Purpose

The purpose of this memo is to document PJM's concerns with Monitoring Analytics' Effective Load Carrying Capability Senior Task Force (ELCCSTF) proposal to remove the performance observations associated with Winter Storm Elliott (WSE), December 22-24, 2022, and Polar Vortex 1 (PV1), January 6-8, 2014, from the resource adequacy risk and accreditation analysis. Removal of these observations significantly reduces overall risk in the model and results in a large shift in risk from the winter to the summer which will substantially change the Forecast Pool Requirement (FPR) and Accredited UCAP (AUCAP) factors. The rationale provided in support of this proposal is the belief that the scheduling actions PJM took during the January 2025 cold weather event will mitigate most, if not all, large-scale correlated outage events in the future. However, a conservative approach to scheduling the system in anticipation of potential, extreme weather events that are forecasted far enough ahead of time, such as was the case in January 2025, is far from a new concept. The advance scheduling steps PJM took in this instance likely had some effect on resource performance as hypothesized later in

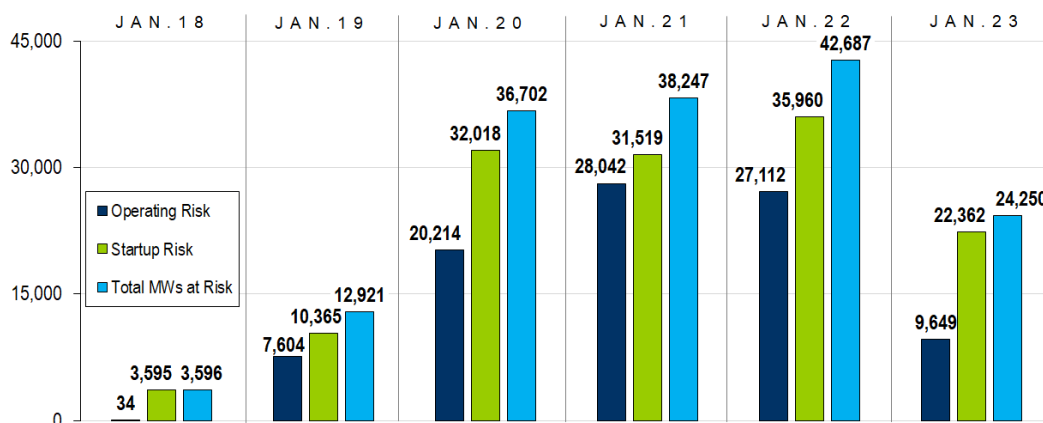
Even with PJM's conservative scheduling in January 2025, the peak forced outage rate during this period reached almost double the annual average.

The average EFORD calculated for the [3rd Incremental Auction for the 2024/2025 Delivery Year](#) was 5.10%. The peak forced outage rate experienced during the January 2025 cold weather event was almost double that at 9.24% as shown on slides 44 and 45 of PJM's [Cold Weather Update to the March 2025 Markets and Reliability Committee](#).

This outage level is higher in total MWs than what was experienced during Winter Storm Gerri in January 2024. During the January 2025 cold weather event, at its highest, there were approximately 17,000 MW of forced outage as compared to about 16,000 MW during Winter Storm Gerri ([see Slide 14](#)).

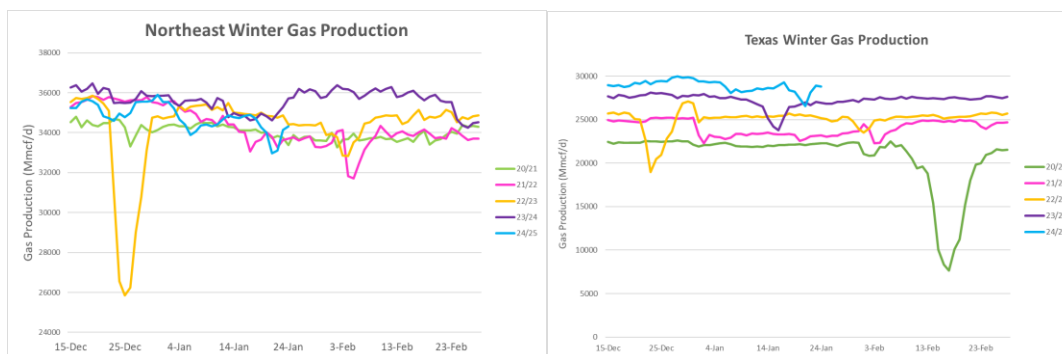
The PJM system experiences natural gas-related risks that are outside of its control but must be accounted for.

Slides 54-56 of the [Cold Weather Update to the March 2025 Markets and Reliability Committee](#) consistently show that there is a drop in natural gas production in the Northeast and Texas that is correlated with well-known cold weather operational events. Exactly how these events impact the availability to procure gas in PJM is not completely known at this time but the fuel availability risk associated with these events is clearly outside of PJM's control and not addressed by conservative scheduling practices. The graph below shows the significant decline in natural gas production observed during the WSE event compared to other recent winter events. The fact that more recent events did not face near the levels of reduced natural gas production as WSE, it is not at all clear how the more recent events provide sufficient evidence that more conservative operations removes the risk of experiencing fuel-related outage levels near those observed during WSE.
